Preliminary Consultation
MONTGOMERY COUNTY HISTORIC PRESERVATION COMMISSION
STAFF REPORT

Address:	5904 Cedar Parkway., Chevy Chase	Meeting Date:	6/13/2018
Resource:	Outstanding Resource Chevy Chase Historic District	Report Date:	6/6/2018
Applicant:	David O'Neil & Laura Billings (David Jones, Architect)	Public Notice:	5/30/2018
Review:	Preliminary Consultation	Staff:	Dan Bruechert
PROPOSAL:	Garage demolition, non-historic addition removal, hardscape, and landscape alterations

Figure 3: Perspective from the southeast of the house in the location of the proposed drive and parking pad.

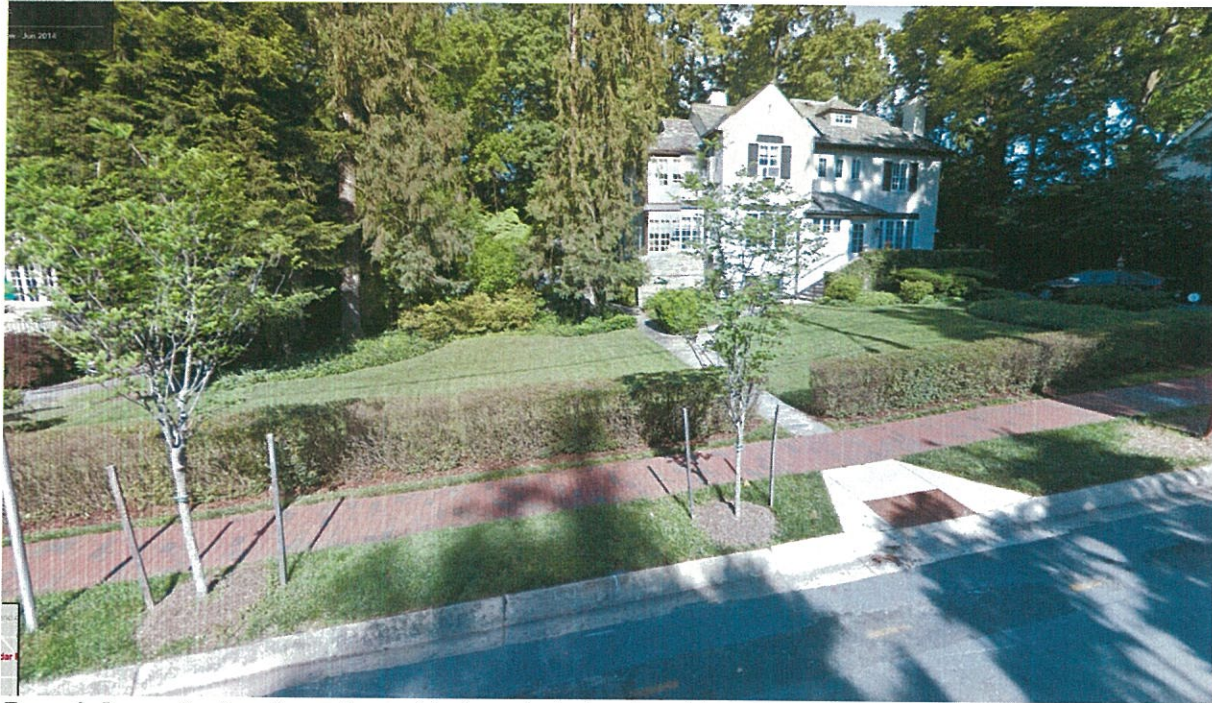
The applicant proposes several alterations to the landscape. The alteration with the largest impact to the streetscape of the building is the proposal to remove the existing asphalt driveway and install landscaping in its place and construct a new drive and parking pad to the immediate left of the historic house. Staff finds that the existing driveway is not sufficient for modern automobiles and believes, historically, the driveway extended onto the neighboring property.

The applicant proposes to construct a new drive and a parking pad wide enough for two cars to the left of the historic house. Staff cannot make a recommendation as to the appropriateness of this proposal without several details. First, the *Guidelines* state that lot coverage is subject to strict scrutiny in view of the park-like setting of the historic district. Details regarding the amount of driveway materials to be removed from their historic location and amount of new paving must be submitted in either a second preliminary consultation or with the HAWP application for a full evaluation. Second, the proposed drive is not shown on any of the renderings or elevation drawings. The driveway must be shown so it can be evaluated for its impact on the streetscape and surrounding district. A perspective drawing from the south east, like the one shown below, would be helpful in determining the impact of this proposed feature. Additionally, it would be helpful for Staff and the HPC to evaluate the proposal if the applicant can show precedent designs within the Chevy Chase Village Historic District.

Materials specifications for the new drive were not provided with the preliminary consultation materials, but Staff has found a variety of materials in the surrounding district including older asphalt, exposed aggregate concrete, and historic smooth concrete. Staff finds that a material with a darker color than modern concrete and with some variety to the texture would be more appropriate if the HPC finds a parking pad in this location would be appropriate.

Existing garage South elevation

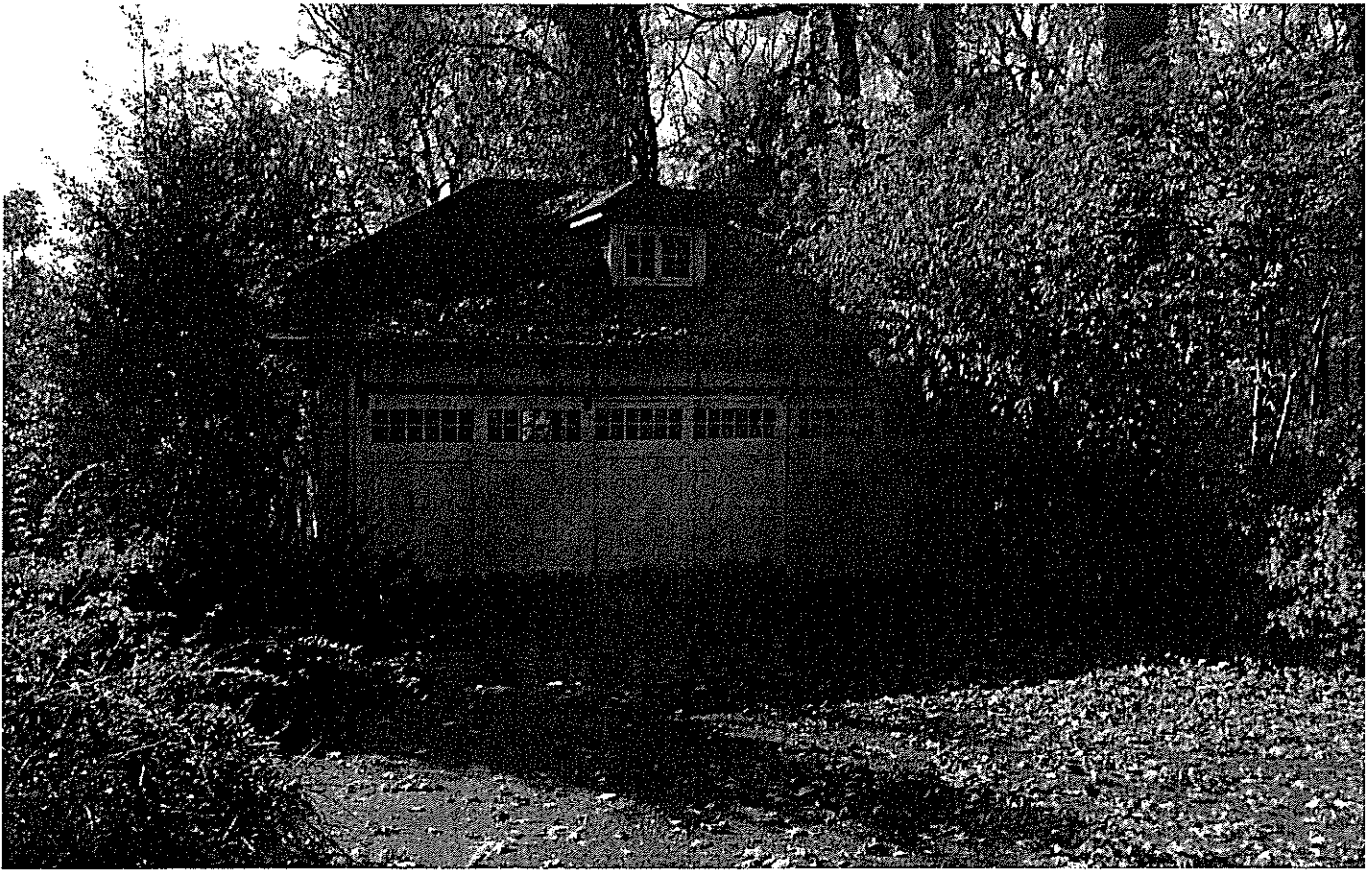
The existing garage is a wood framed building on a brick foundation with an asphalt-shingled hipped roof with a hipped dormer. The doors are all wood carriage style doors with lites in the upper section. The construction date of the garage has not been conclusively shown, however, Staff's research into Sanborn Maps and County Atlas, demonstrate that the garage was constructed sometime after 1948. Due to the placement of the garage at the rear of the yard and the slope of the lot and the terracing of the side yard the garage is only minimally visible from the public right-of-way. The applicant proposes to demolish this building.

The *Guidelines* relating to detached garages states that alterations should be reviewed under lenient scrutiny, meaning the review should focus on general massing and scale and impact on the streetscape. As it is only minimally visible from the surrounding streetscape, Staff finds that the removal of the garage would not have an impact on the surrounding district. Additionally, the *Guidelines* adhere to the principle that: "Alterations to the portion of a property that are not visible from the public-right-of-way should be subject to a very lenient review. Most changes to the rear of the properties should be approved as a matter of course." Even though 24A-8(b)(1) states that changes will not significantly alter an historic resource within a historic district, Staff finds support for demolishing the existing garage.

ILLUSTRATIVE SITE PLAN

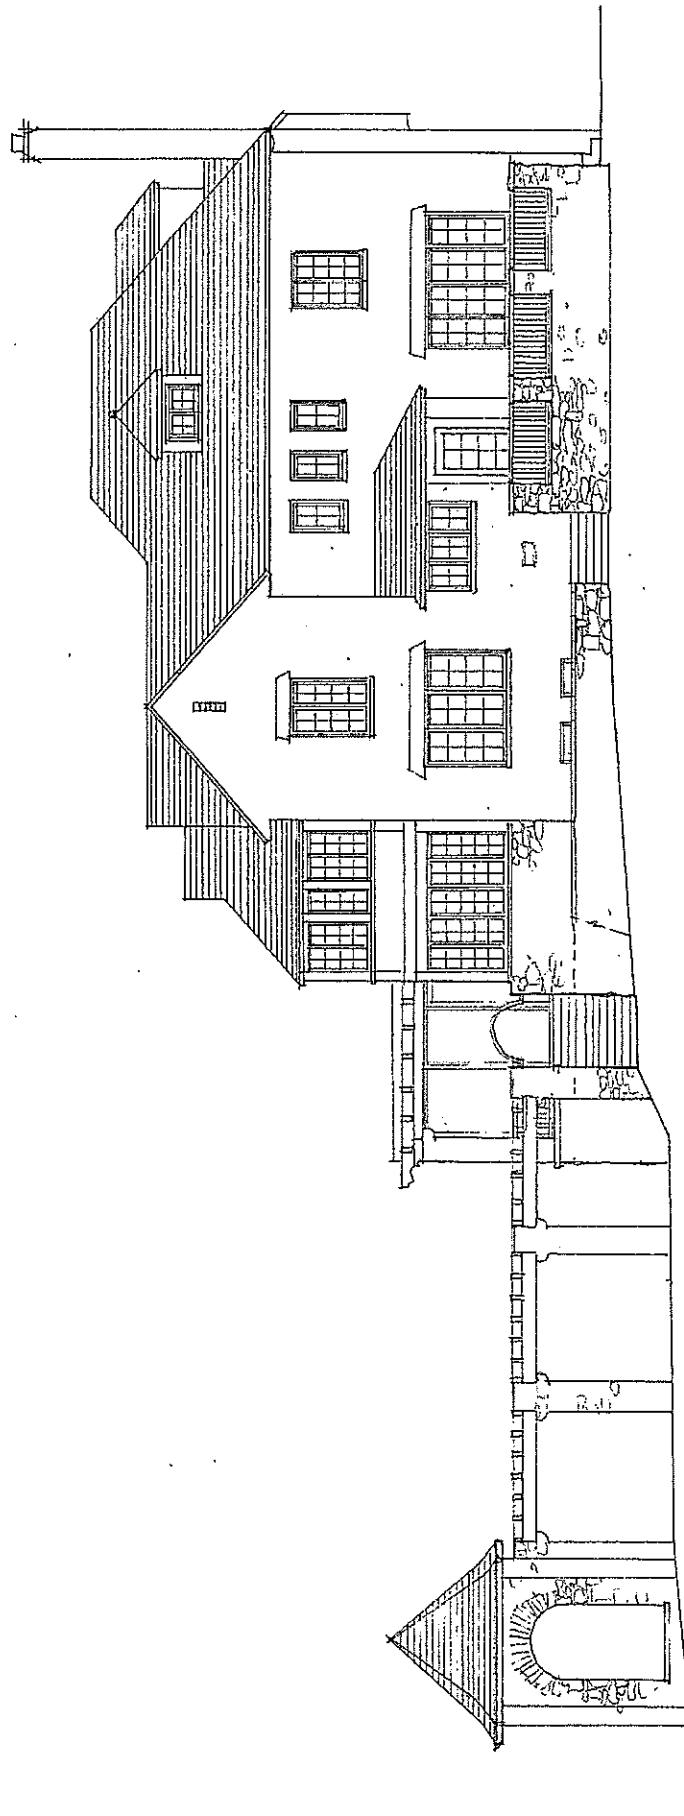
Adjacent to the proposed pool, the applicant proposes to construct a new accessory structure. The only details provided for this new building are shown on the landscape concept drawing (circle: ____). Sufficient details were not provided for Staff to make an evaluation of the design. Based on Staff's observations at the site, this building will likely be largely obscured by the arbor/ pergola, but may be minimally visible from an oblique view. As it is a detached accessory building, the *Guidelines* state that it is subject to lenient scrutiny. Staff recommends that the new accessory building take its design cues from the historic garage to ensure design compatibility (per 24A-8(b)(2)).

In the rear of the lot the applicant is proposing to construct several new retaining walls. The rendering shows that they will be stone. Staff finds that this is an appropriate material; however, detailed specifications were not provided. Staff request the HPC provide guidance to the applicant regarding new retaining walls and hardscaping. Staff recommends the applicant revise the proposed hardscape based on feedback from the HPC and return with more details and specifications for a second preliminary consultation or HAWP.
